PLANNING COMMITTEE 21st April 2022

ADDENDUM LIST

AGENDA ITEM 4 APP/21/01248 - 22 FARR Hall Drive,

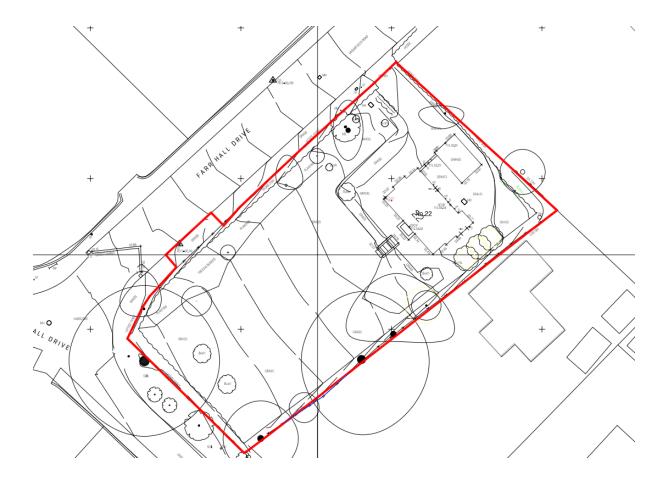
The redline of the site plan was amended in response to neighbour's concerns regarding site ownership, anomalies within the drawings and a requirement for the attenuation tank to be located outside RPAs. The amendments are summarised as below.

Plans/Drawings	Difference
B100 C Existing Site & Location Plan (Submitted 23.11.2021)	The redline was amended to be smaller. The blue line is the original red line and the red line is how it has been amended.
B102 AA Proposed Site Plan (Submitted 23.11.2021)	The redline was amended. For ease the attached plan illustrates the difference. The blue line is the original red line and the red line is how it has been amended.
B103 Y Floor Plans & Roof Plan (Submitted 25.10.2021)	This plan addressed the anomaly with the second floor windows and roof lights in the floor plans and roof plan.
B109 K Proposed Site Sections (Submitted 25.10.2021)	The existing ground levels are shown on the site sections in red.
ELL-19017-HH-L-101 A01 Drainage Layout (Submitted 23.03.2022)	The storge tank and new drainage run to a new combined manhole are outside the RPA's of T7 and T10. The storage tank and drainage run are located in the 4 car parking spaces

The following sets out the extent of the changes to the site location plan. The blue line marks the previous extent of the redline line as per the original submission.
